Objector:	Mr Mark McGarry
Organisation Name:	AXIS Environmental Services
Objector Address:	Unit 3 Westlink Business Park, Clondrinagh, Limerick, Co. Limerick.
Objection Title:	Objection #OS010240 - Applicant objection for Reg No:[P0606-04]
Objection Reference No.:	OS010240
Objection Received:	06 March 2022
Objector Type:	Applicant
Oral Hearing Requested?	No

#### SSE Great Island: Industrial Emissions Licence Review P0606-04

I refer to the Agency's Industrial Emissions Licence Proposed Determination (P0606-04), issued on the 09<sup>th</sup> February 2022, regarding the above Licence review application. SSE welcome the proposed Determination in principal and look forward to complying with its conditions as set out.

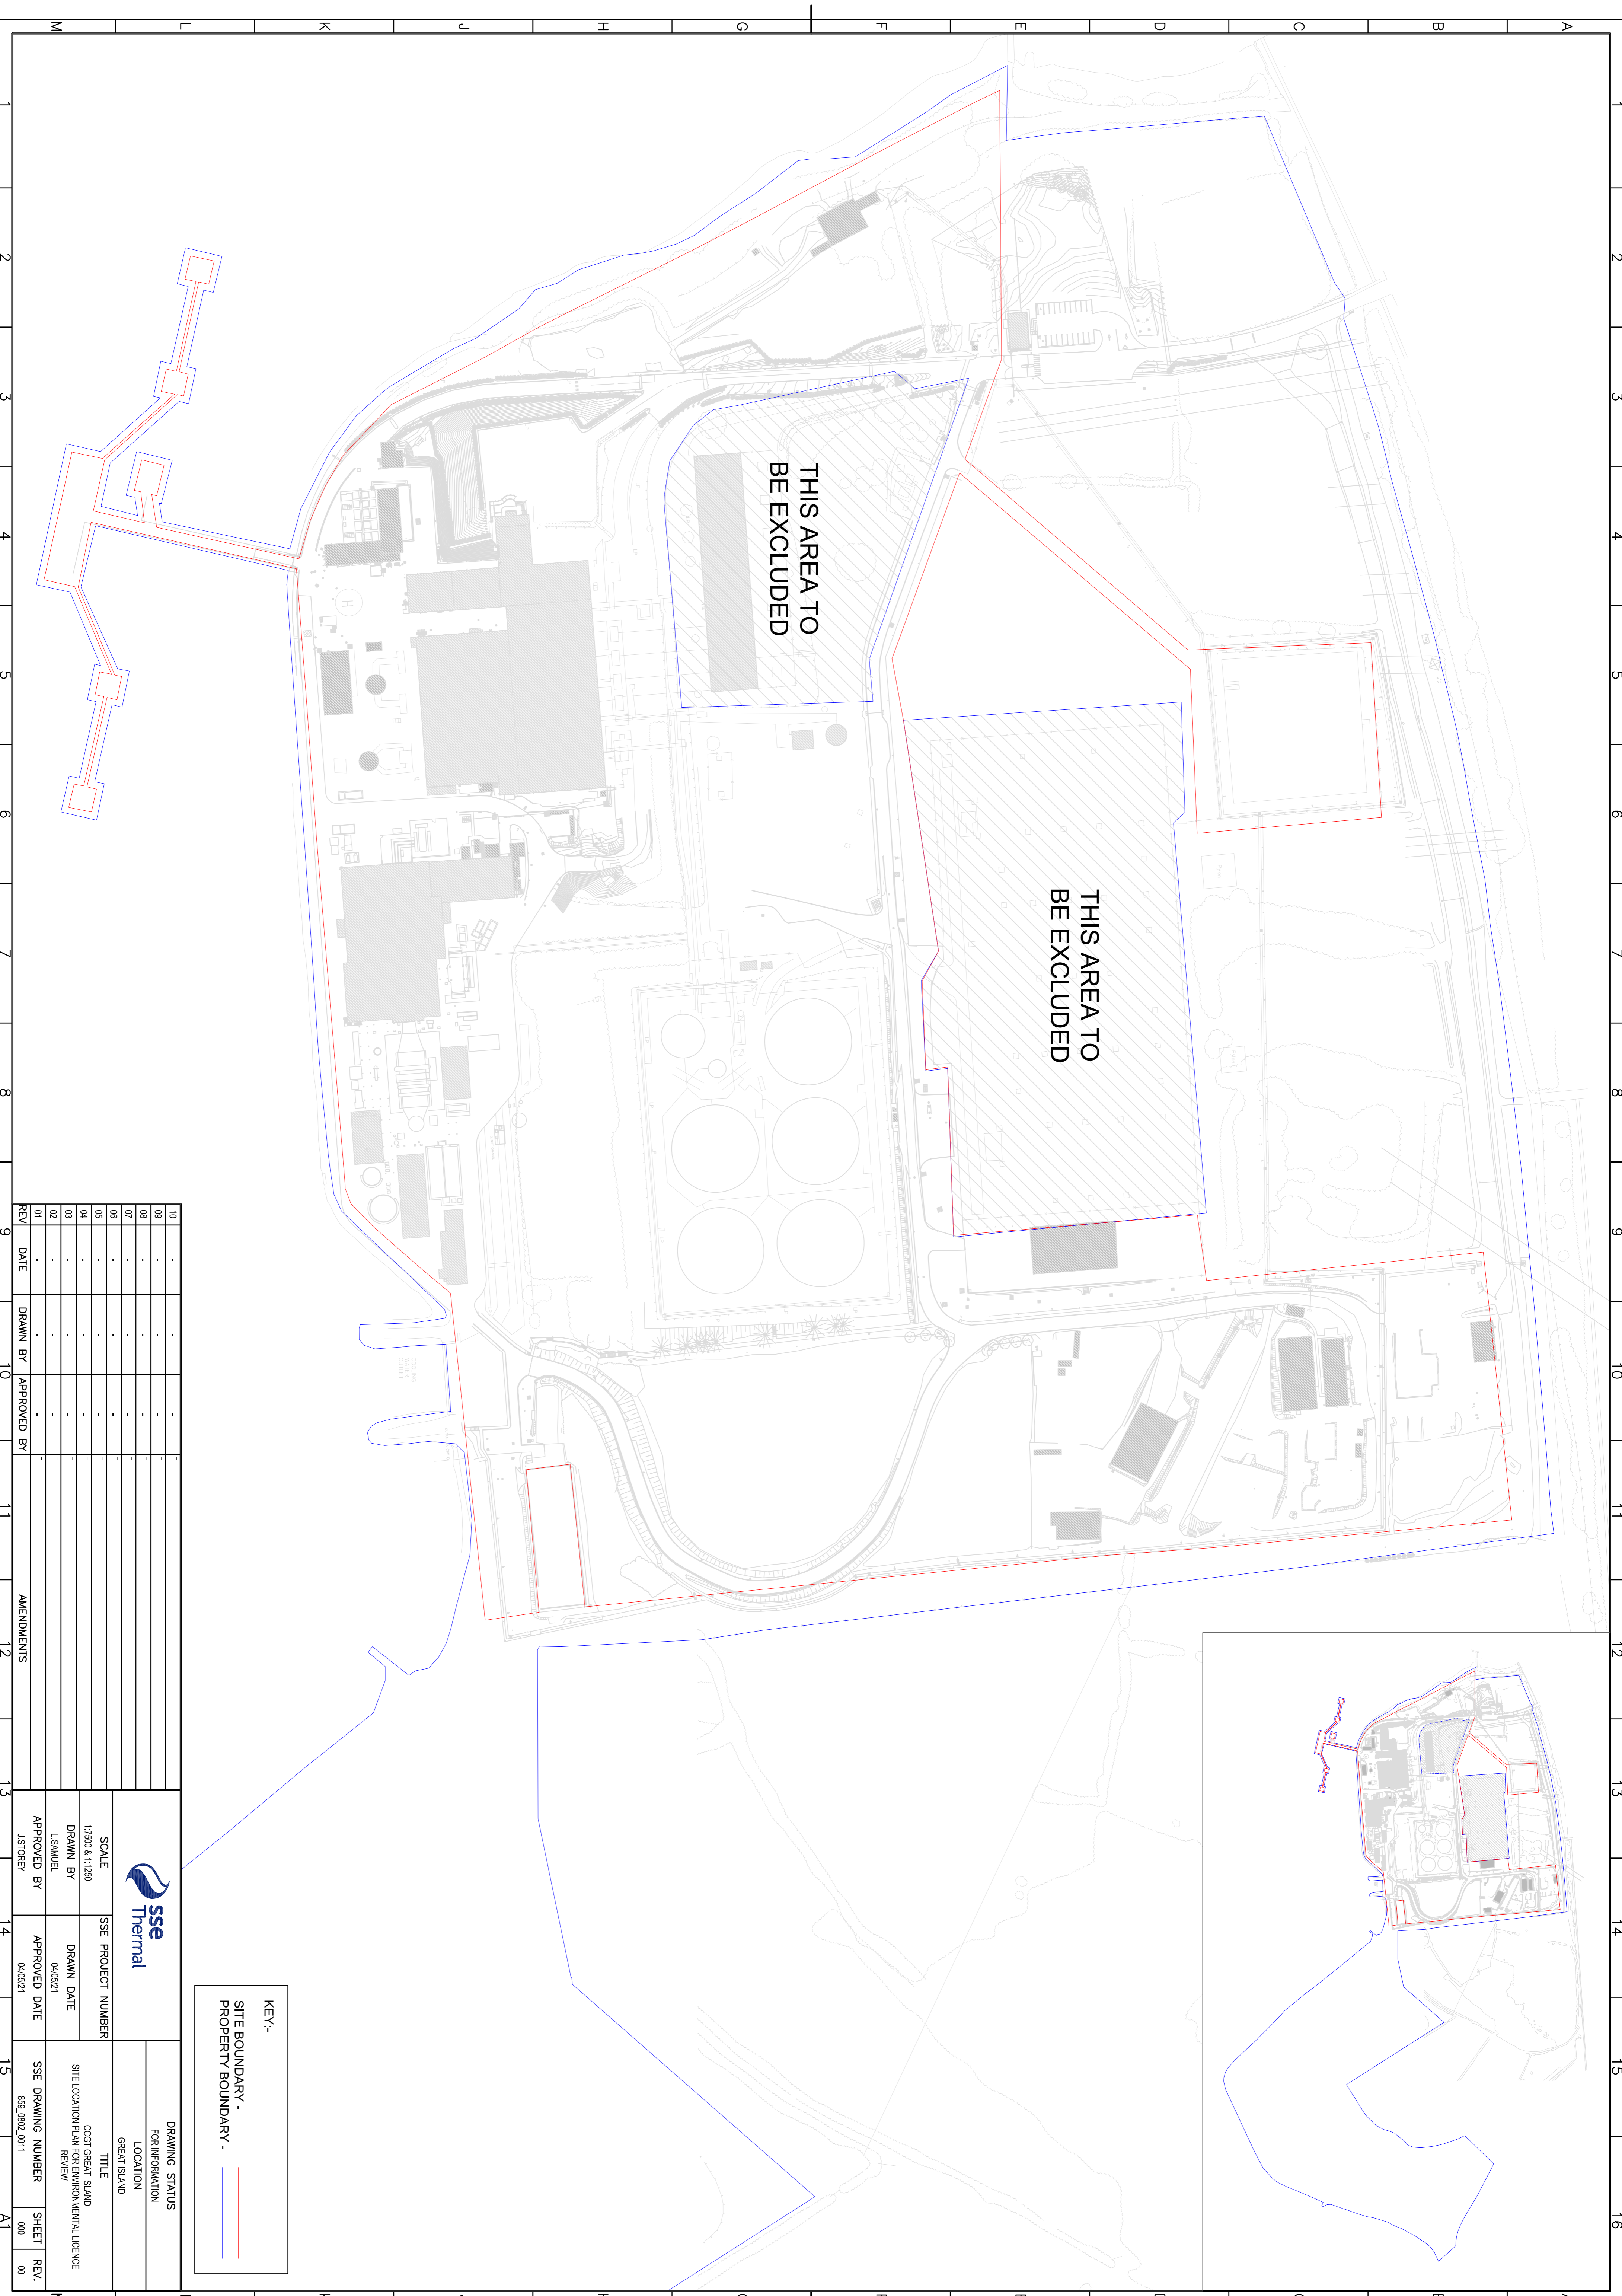
We have attached a drawing of the Installation (SSE Drawing Number: 859\_0802\_0011) as operated by SSE to carry out the activity “2.1 Combustion of fuels in installations with a total rated thermal input of 50 MW or more”. The map outlines the three distinct areas of the installation:

1. The property boundary is outlined in Blue. This is the property boundary under the legal ownership of SSE. The area owned by SSE is not used in its entirety for this activity under review. Portions of this land are leased to alternative businesses which have no link to or association with the activity under licence;
2. The site boundary is outlined in Red. This is the area that is operated for and directly relates to the activity under review “2.1 Combustion of fuels in installations with a total rated thermal input of 50 MW or more”;
3. Excluded Areas are shaded. There are two areas within the red boundary line which are operated by Electrical subcontractors and the ESB. These are also excluded from the activity under licence as they are not associated with or owned by SSE.

We would request for the record that the drawing attached is referenced into the licence as to what portion of the installation is associated with the activity under licence review.

1.3 “For the purposes of this licence, the installation authorised by this licence is the area of land outlined in **red** on Drawing No. 859-0802-0011 submitted as part of the application on 07\* May 2021. Any reference in this licence to “installation” shall mean the area thus outlined in **red, not including the two shaded areas marked on the drawing as “This area to be excluded”**. The licensed activity shall be carried on only within the area outlined”

Title:  
**Proposed  
 Monitoring  
 Point - ASW1**

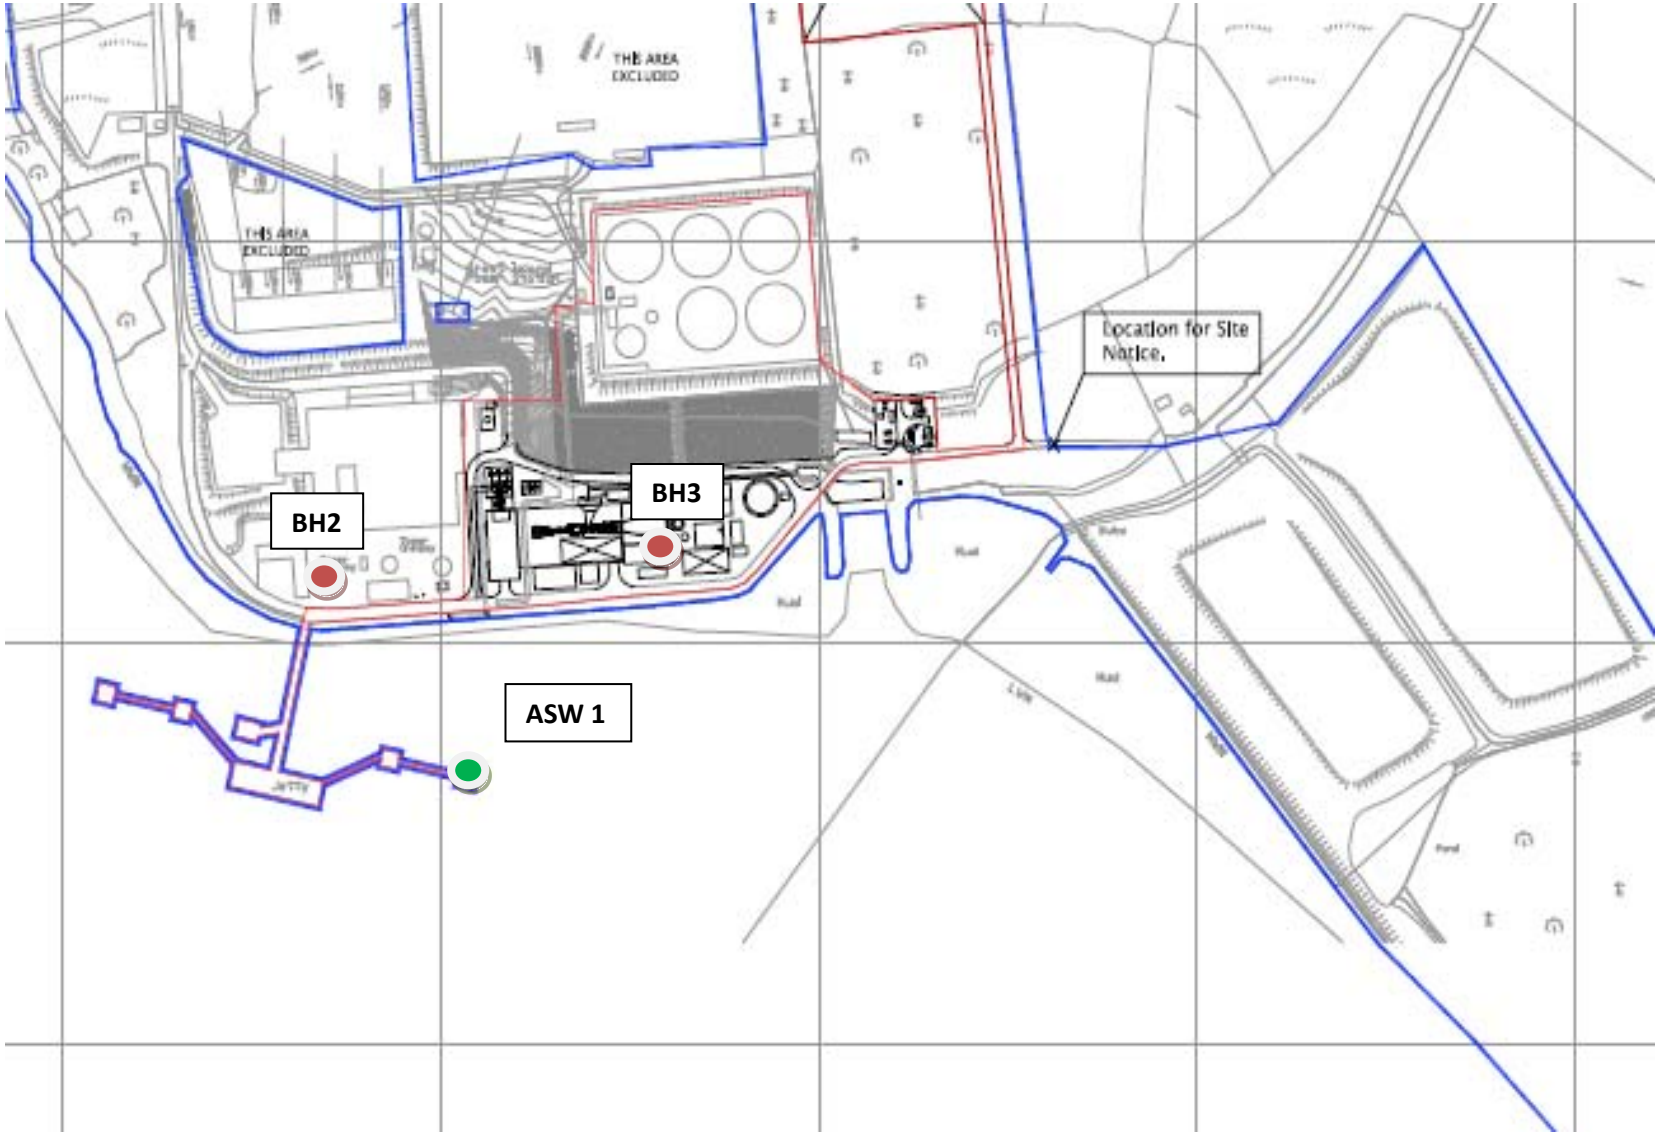
The Proposed Determination inserts a condition to agree a suitable monitoring location for receiving water monitoring. This location has previously been agreed and tested at this location since 2011. As this has previously been agreed with the Agency (see correspondence attached), SSE would like to formalise the location in this licence.

6.19 Receiving Water Monitoring – SSE request to remove this condition from the licence and the sampling location as already agreed with the Agency be listed in Schedule C.5 as outlined below.

Location: ASW1 – (268772 N, 114417 E)
